Town of Parker Community Development Department  
Development Review Division  
Attention: **Stacey Nerger**

Application Type: **Site Plan Major Amendment – Non-Residential**  
Status: **First Referral**  
Application Name: The Exchange L1 – Site Plan Amendment Addition & Remodel  
Case/AP#: **SP23-080**  
Referral Received: October 17, 2023  
Comments Due: November 15, 2023

Review date: **November 3, 2023**  
Plan reviewer: **Randall L. Capra**, [rcapra@parkeronline.org](mailto:rcapra@parkeronline.org)  
Phone: 303.805.3163

<b>TOWN OF PARKER - FIRE/LIFE SAFETY:</b>	<b>R REVIEWED FOR CODE COMPLIANCE; REVISIONS REQUIRED</b>
---	---

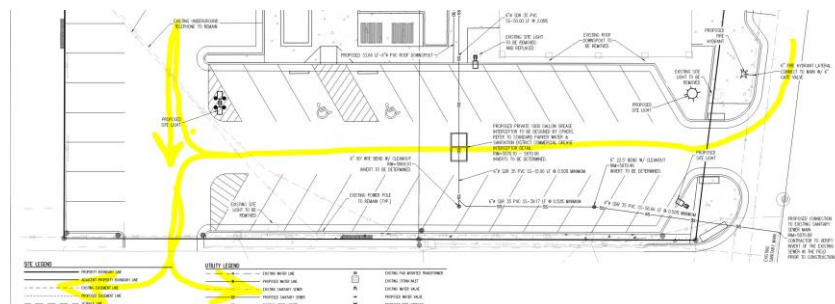
5. The applicant shall provide a room layout (in advance of a plan set for the commercial building permit) so as to ensure that the riser room is sized appropriately. With regard to the fire sprinkler control valve room, ensure that the following is addressed: *Not satisfied; the applicant has noted, acknowledged, with the second submittal while the floor plan for the room was not provided. The purpose of this requirement, and why it is noted at this time, is to ensure that there is not a problem down the road. This issue is required to be addressed prior to life safety sign off... which is why it was mentioned in the first response. Not satisfied with the third submittal; the utility plans do not show the location of the riser room let alone dimensions, locations of FACP and riser, clearances, etc. This issue shall be readdressed with the fourth submittal. Note – I did find a location on the Site Plan though the layout has not been provided as REQUIRED; see below: Not satisfied with the fourth submittal; as noted above, an architectural floor plan of how the riser room is to be laid out is required prior to approval. Information on how this room is to be laid out is provided below. Address this issue when resubmitting.*

- Exterior access is required into the riser room with access into the building provided either adjacent to the riser room or through the riser room.

- The FACP will be required to be located on an interior wall in the fire sprinkler control valve room; ensure that the riser room is sized to accommodate the FACP and the riser. A three-foot clearance is required in front of the FACP as well as the sprinkler riser.
- The underground shall enter the building and turn up no further than 24 inches from foundation wall; three feet of clearance is required in front of the fire riser with a minimum of 12" of clearance behind the riser and 18" to each side of the riser.
- The FDC location requires three feet of clear space on either side of the FDC... just as a fire hydrant requires the same clear spaces.

**Note – This is a requirement that is not allowed to be deferred until the building submittal has been made. Exterior door access, riser room location, water entry, etc. all must be confirmed prior to site plan approval. Please work with your design team to ensure that the required information is provided. The site plan will not be approved without the required information.**
